**Responses to EPA's Comments to the Draft Human Health
Risk Assessment, And EPA's And RIDEM's Comments to
the Draft Screening Level Ecological Risk Assessment and
Draft Phase I Remedial Investigation Report of
IR Program Site 16**

**Naval Construction Battalion Center
North Kingstown, Rhode Island**

January 2002
Version: FINAL
EA Project No.: 29600.97.3592

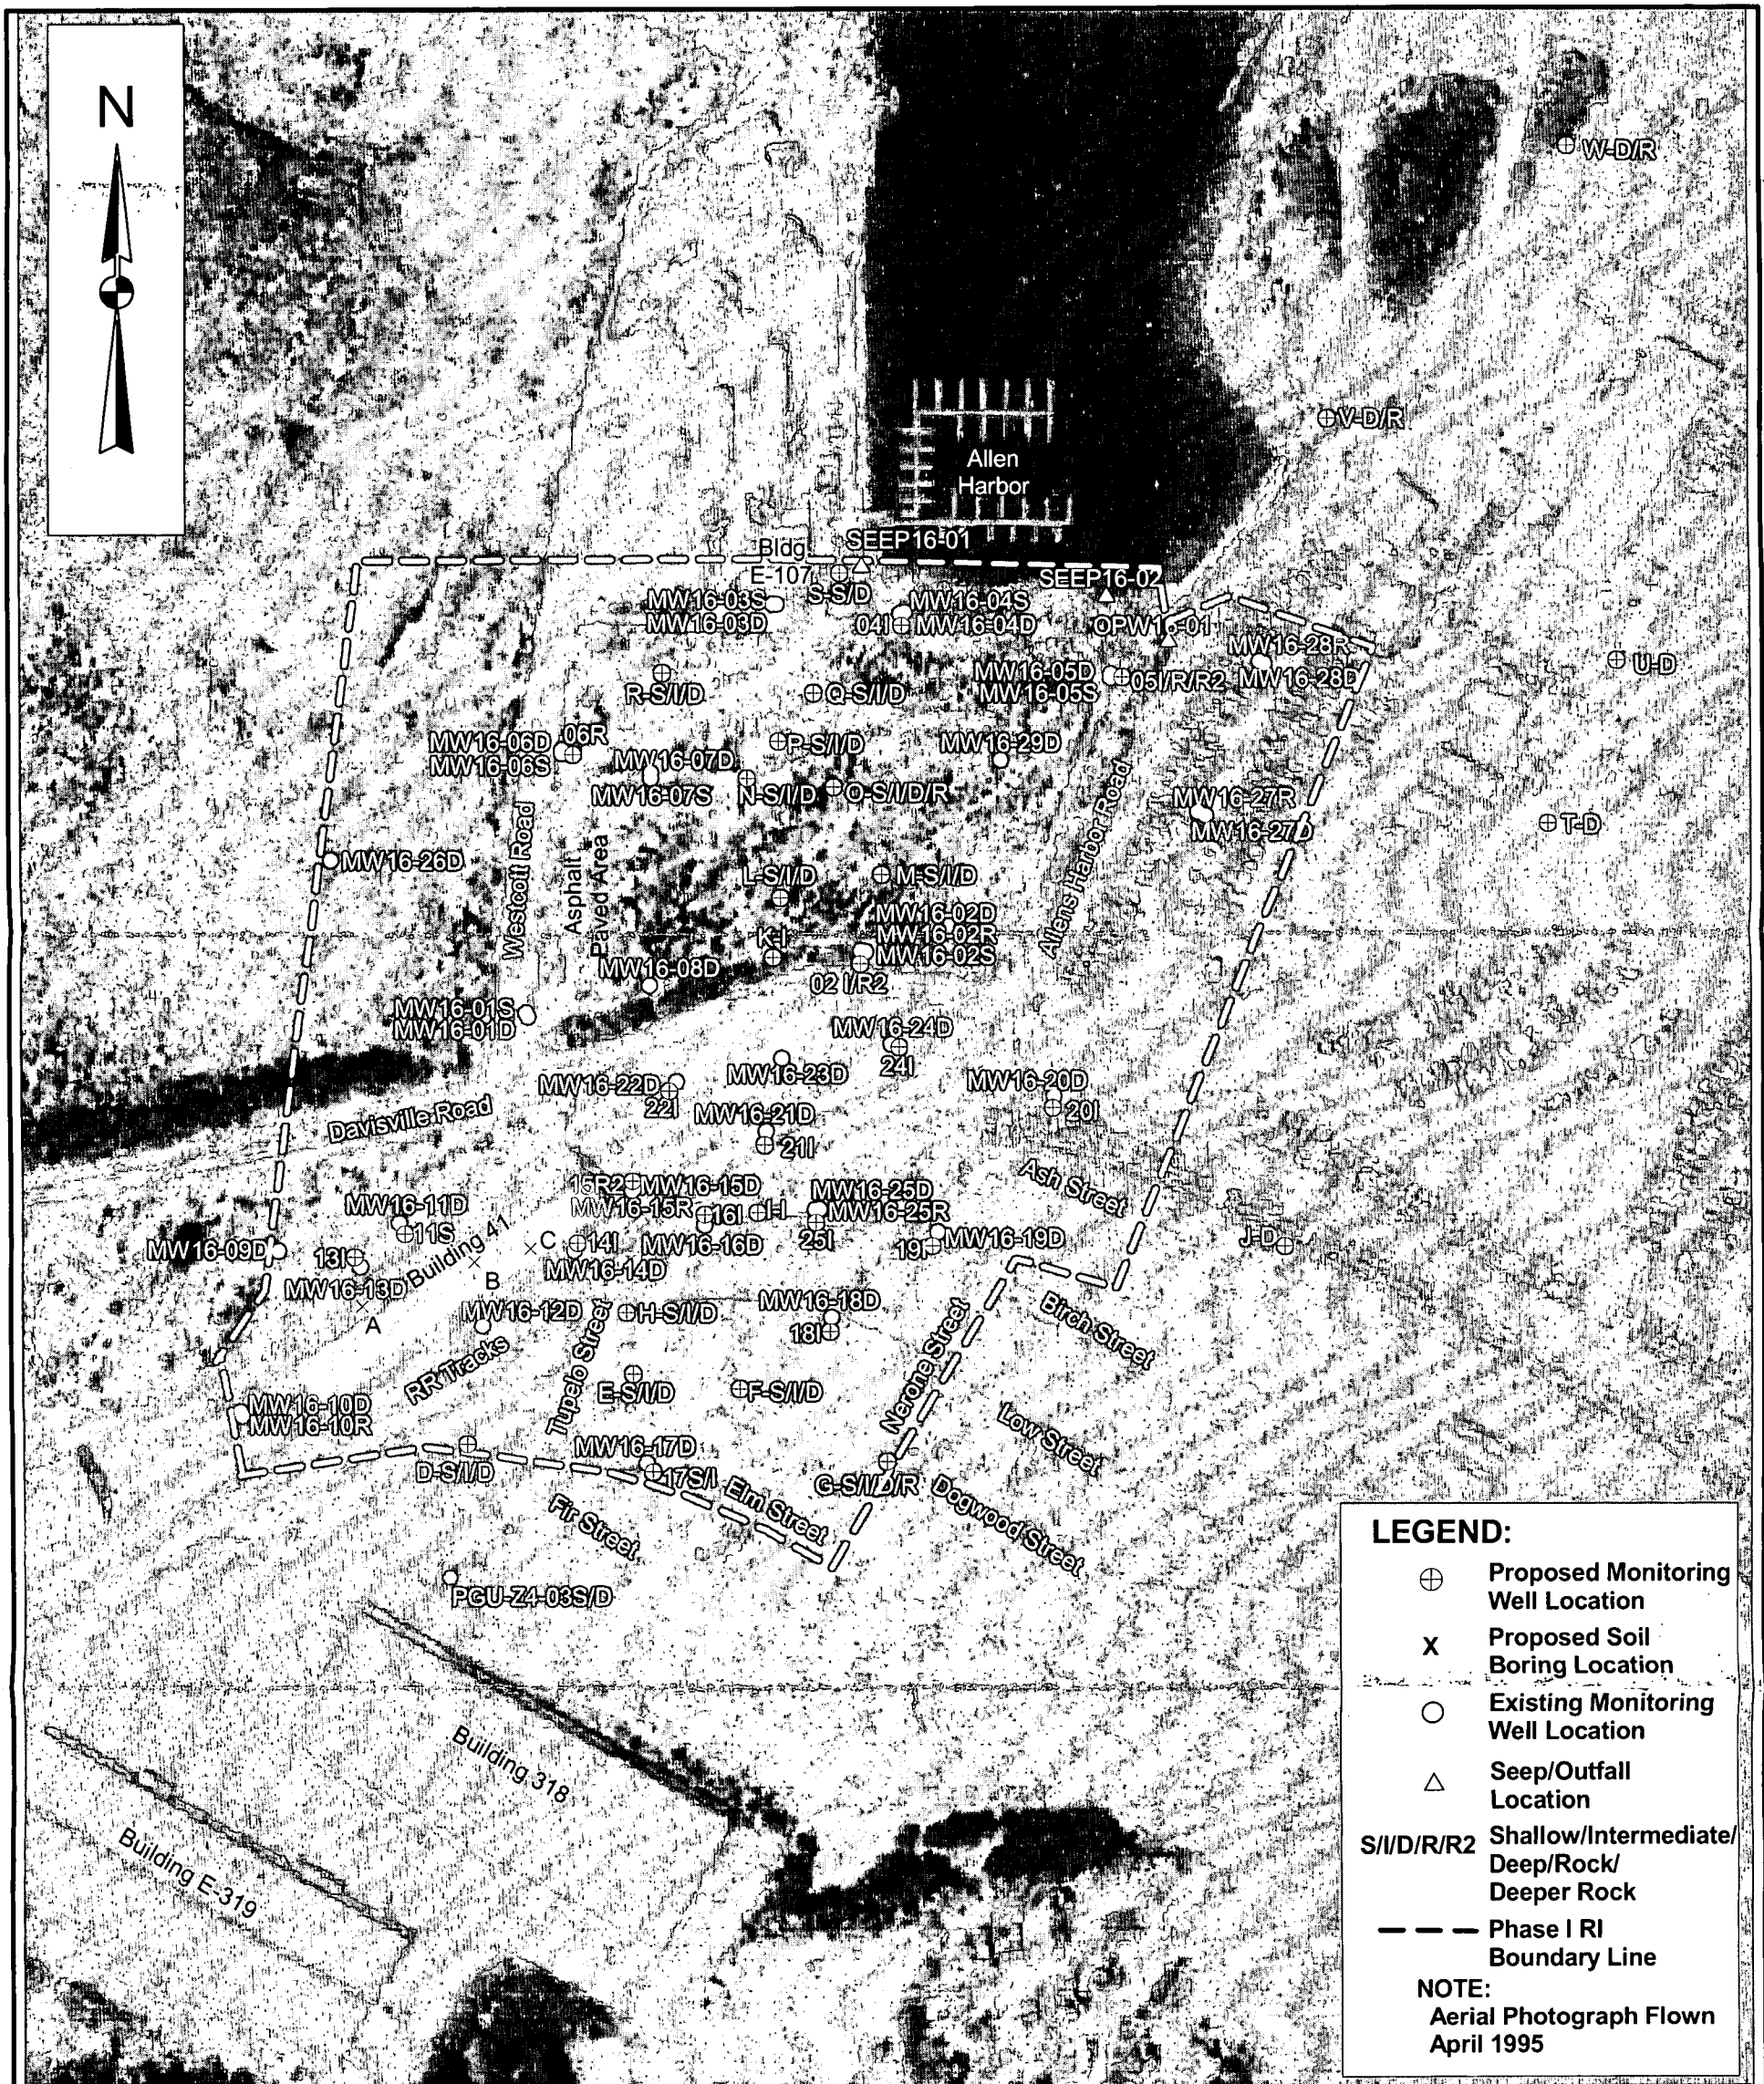
G-S		Assess shallow overburden GW interval (silt layer[s] presence, direction of GW flow, and VOC presence) along Dogwood Street in the old railroad spur area.
H-S		Assess shallow overburden GW interval (silt layer[s] presence, direction of GW flow, and VOC presence) along Low Street in the old railroad spur area at the former SB16-29 (55 µg/Kg TCE detected in soil sample from 20-22 ft bgs) and MIP16-S21 locations. Also, located potentially downgradient from Building 41.
L-S		Assess shallow overburden GW interval (silt layer[s] presence, direction of GW flow, and VOC presence) in the Stage I RI area at the former MIP16-11 location where there was a very low to low ECD response about 6-17 ft bgs.
M-S		Assess shallow overburden GW interval (silt layer[s] presence, direction of GW flow, and VOC presence) in the Stage I RI area at the former MIP16-17 location where there was a low ECD response about 5-49 ft bgs and where 9 µg/L vinyl chloride and 15 µg/L total 1,2-DCE detected in push probe sample 12 ft bgs.

N-S		Assess shallow overburden GW interval (silt layer[s] presence, direction of GW flow, and VOC presence) in the southwest corner of the suspected former FFFTA south of the former EBS 28-GW-04 location where 10 µg/L vinyl chloride detected in push probe sample 7-9 ft bgs.
O-S		Assess shallow overburden GW interval (silt layer[s] presence, direction of GW flow, and VOC presence) southeast of the suspected FFFTA at the former MIP16-15 location where there was a trace? ECD response about 6-17 ft bgs and where 11 µg/L vinyl chloride and 230 µg/L total 1,2-DCE detected in push probe sample 17 ft bgs.
P-S		Assess shallow overburden GW interval (silt layer[s] presence, direction of GW flow, and VOC presence) within the suspected FFFTA north of the former MIP16-12 location where there was a low and very low ECD response about 6-8 and 15-19 ft bgs, respectively, and where 14 µg/L vinyl chloride and 255 µg/L total 1,2-DCE detected in push probe sample 17 ft bgs.

Boring/Well Designation	Zone to be Screened	Purpose / Rationale
Q-S		Assess shallow overburden GW interval (silt layer[s] presence, direction of GW flow, and VOC presence) northeast of the suspected FFFTA at the former MIP16-14 location where there was a very low ECD response about 6-9 and 14-16 ft bgs and north of the former EBS 28-GW-05 location where 3 µg/L vinyl chloride detected in push probe sample 8-10 ft bgs.
R-S		Assess shallow overburden GW interval (silt layer[s] presence, direction of GW flow, and VOC presence) in northern portion of the former creosote dip tank area at the former MIP16-05 location where there was a very low to low ECD response about 3.5-12 ft bgs.
S-S		Assess shallow overburden GW interval (silt layer[s] presence, direction of GW flow, and VOC presence) between Building E-107 and Seep 01 at the former MIP16-30 location where there was a trace ECD response about 2-3 ft bgs.

MW16-02I	Intermediate Overburden (I)	Assess intermediate overburden GW interval (direction of GW flow and VOC presence) between silt layers where there was elevated soil sample headspace values (32-36.5 ft bgs).
MW16-04I		Assess intermediate overburden GW interval (direction of GW flow and VOC presence) where silt layers were not encountered, but where there was elevated soil sample headspace value (28-30 ft bgs).
MW16-05I		Assess intermediate overburden GW interval (direction of GW flow and VOC presence) between the shallow and deep overburden screened intervals and above the deeper 2 silt layers where there was elevated soil sample headspace values (21-36 ft bgs).
MW16-13I		Assess intermediate overburden GW interval (VOC presence) just north of the former vapor degreasing pit in Building 41 and above the top of the 2 silt layers that is at 34 ft bgs (no elevated soil sample headspace values).
